Planning Commission Staff Report

Project Type: Site Development Section Plan

Description: **Chesterfield Blue Valley, Proposed Lot 10 (Premium Outlets)**: A Site Development Section Plan, Landscape Plan, Lighting Plan, Architectural Elevations, and Architect's Statement of Design for a 50.72 acre tract of land zoned "PC" Planned Commercial District in the northeast corner of the development located on the north side of Olive Street Road, west of its intersection with Chesterfield Airport Road.

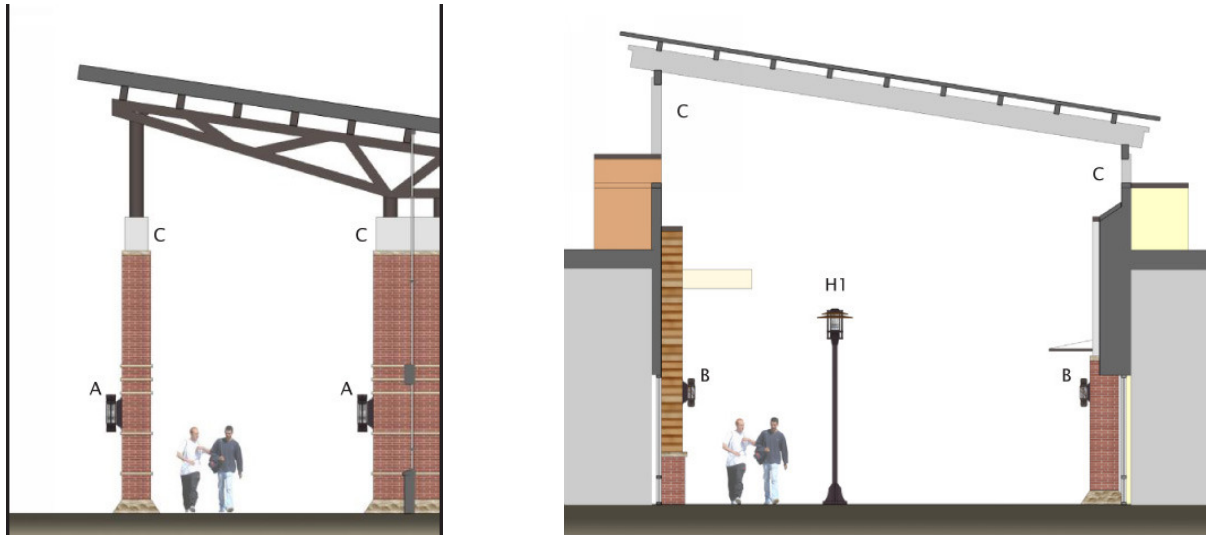
In order to clarify the visual impact of these fixtures, architectural sections were provided to show how the fixtures will be utilized in enhancing pedestrian experience and the architecture of the buildings.

** Fixtures shown on the sections above are from the Chart on the previous page: A & B. PKSA/PKSP; C. SPI; H1. PKWM

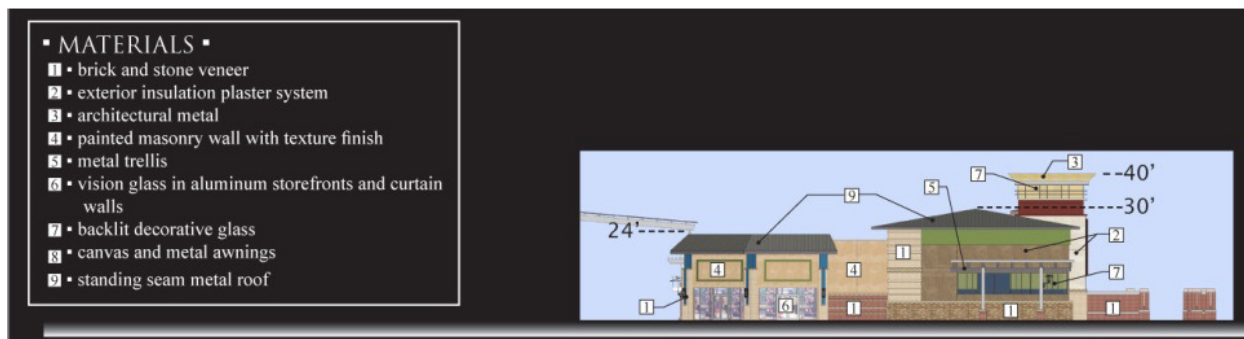
1. Consider providing additional tree coverage in the promenades.

The applicant has submitted a letter stating that they will add additional trees to the areas east and west of the Food Court area. Additionally tree locations have been identified in the main east and west pedestrian entry areas. The trees are proposed as three (3) different ornamental tree types. The plan does not need to be amended to show these locations as they are internal to the site. They will be required to be planted within the identified planter locations in the pedestrian boulevards.
